MARQUETTE CITY PLANNING COMMISSION
Tuesday, November 12th, 2024, at 6:00 p.m.
Commission Chambers at City Hall – 300 W. Baraga Ave.

TO: Planning Commission
FROM: Andrea Landers, Zoning Official
DATE: October 25, 2024
SUBJECT: 16-SPR-11-24 – YMCA Building Addition 401 E. Fair (1420 Pine St.)
(PIN: 0511040)

Staff has reviewed the proposed site plan for the construction of a two-story addition (Option 1 +/-14,500 S.F. or Option 2 +/-19,300 S.F.) and site improvements for 401 E. Fair (1420 Pine St.), and has provided comments regarding the plan.

ELECTRICAL SITE PLAN
SCALE: 1 INCH = 30 FEET

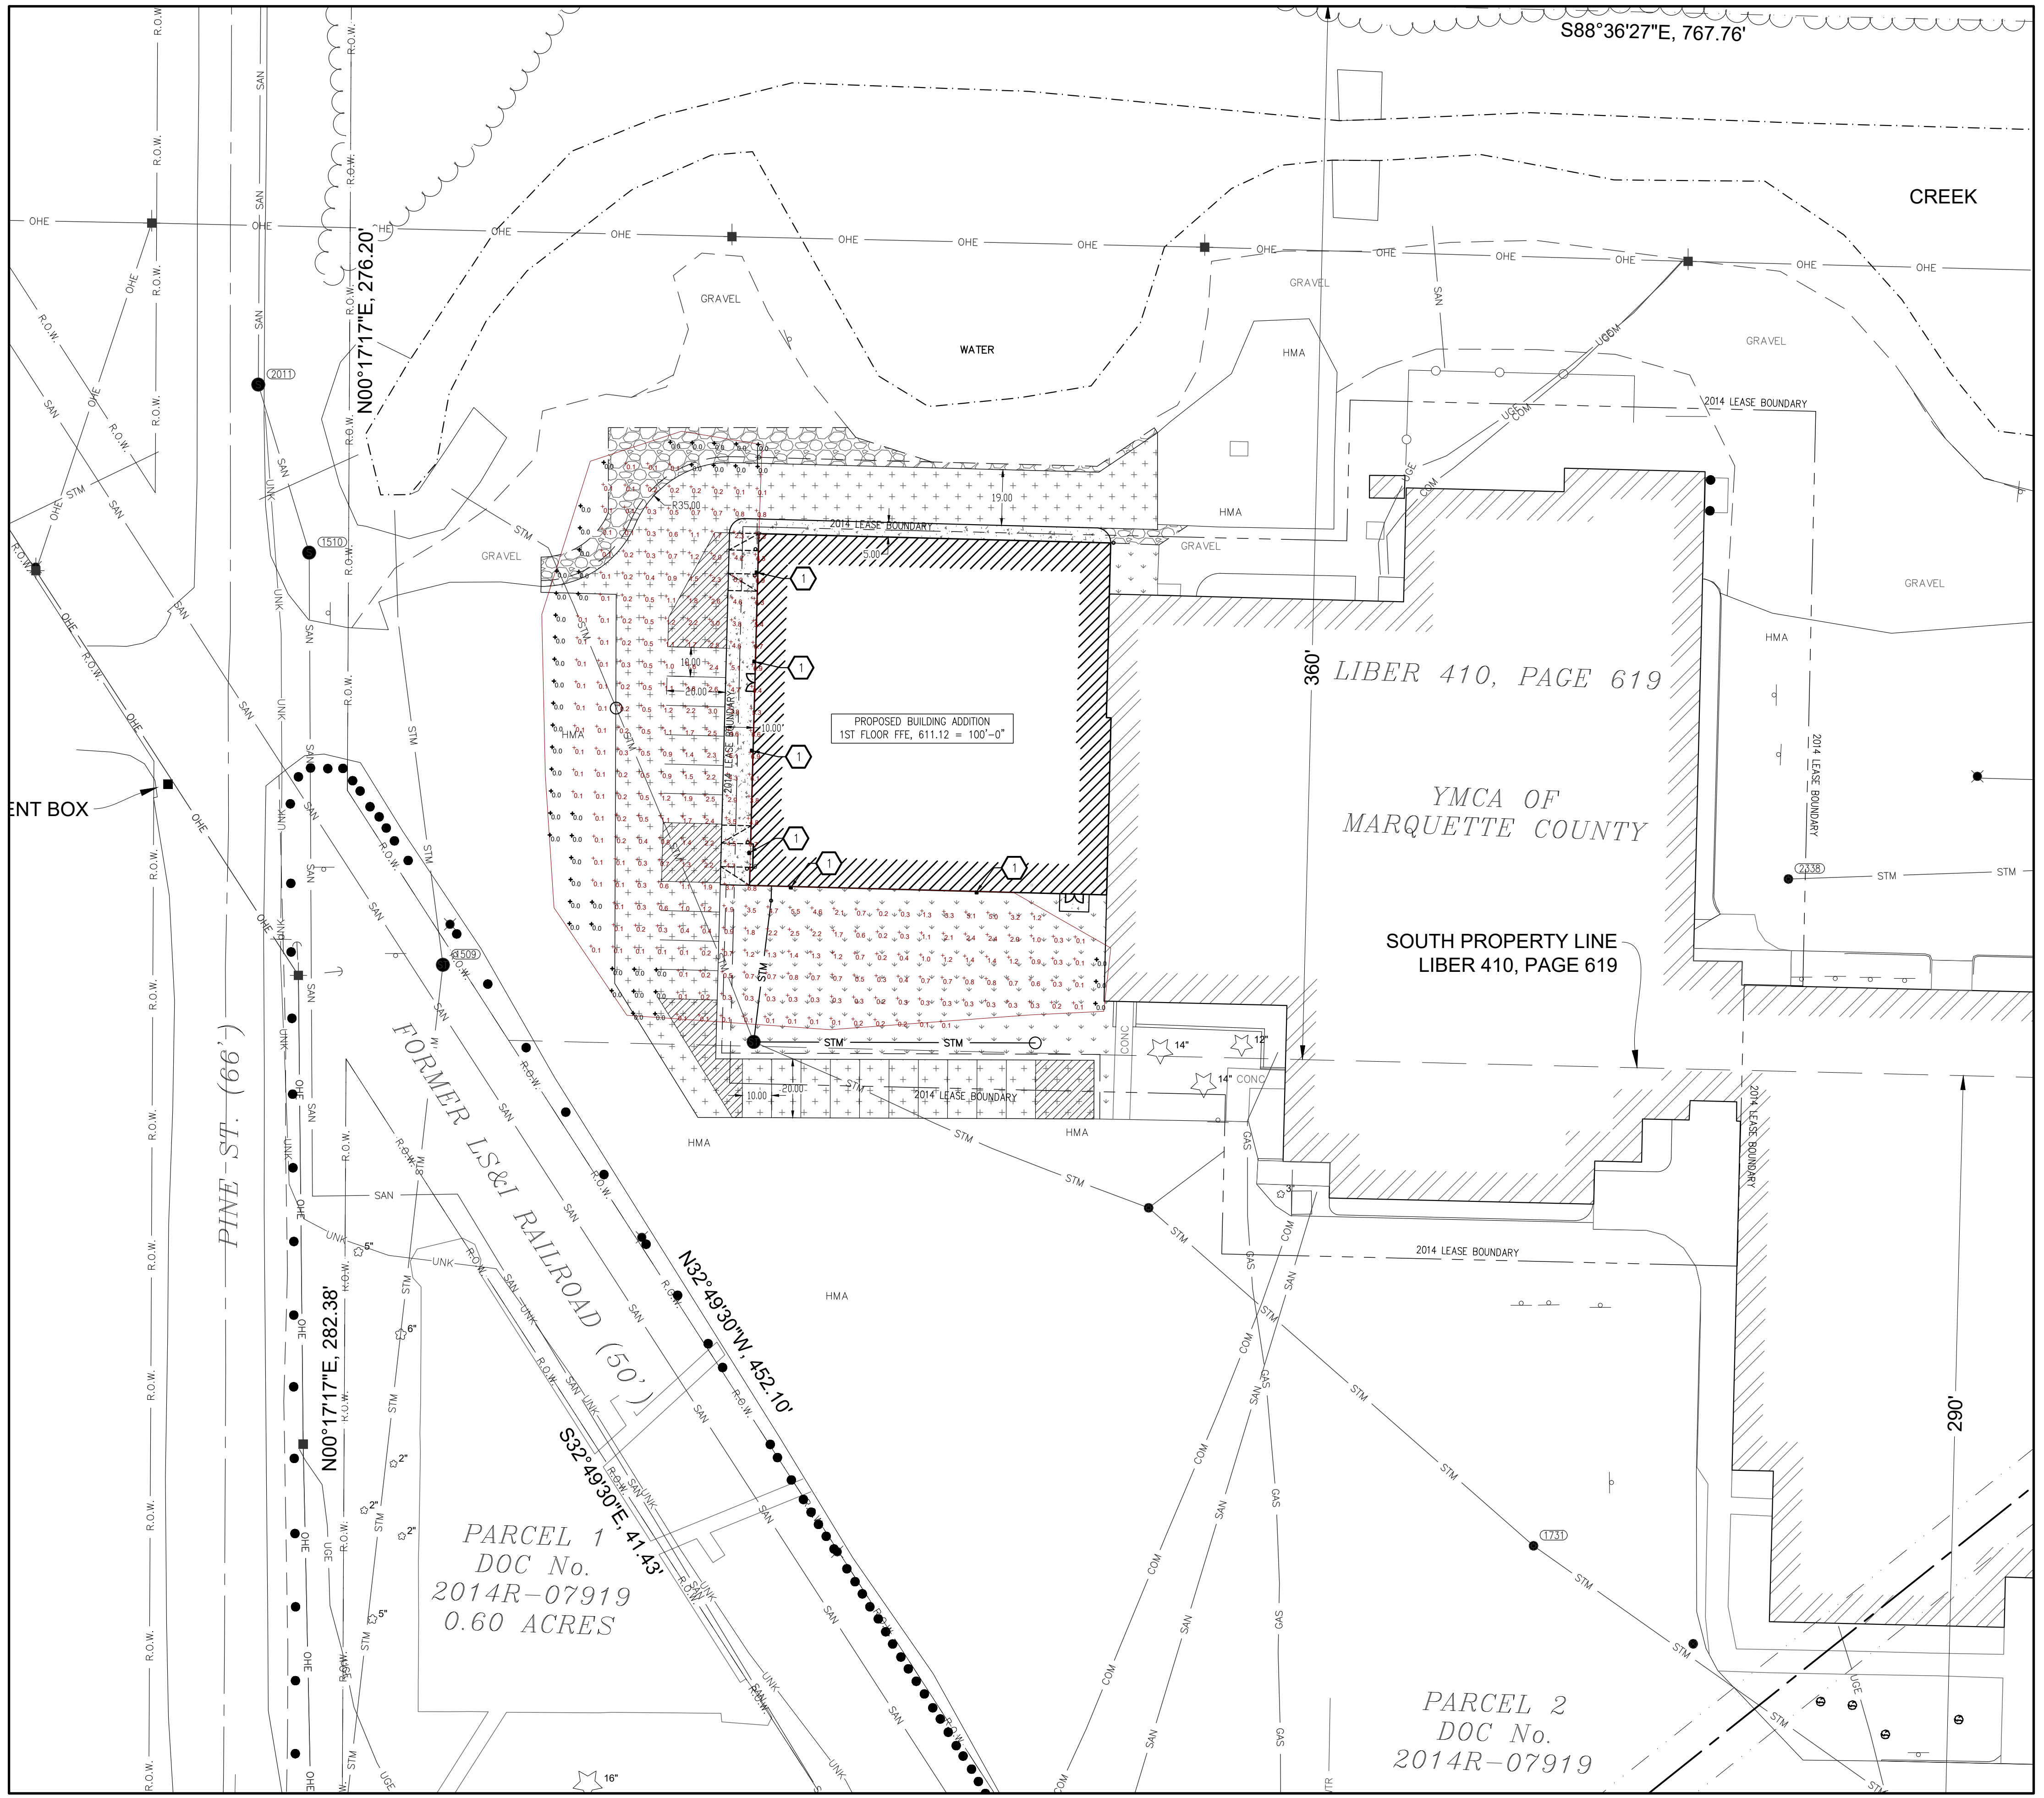
Per the sheet ES1.0, there will 6 new wall lights on the proposed addition. Please also see the attached cut sheets they submitted.
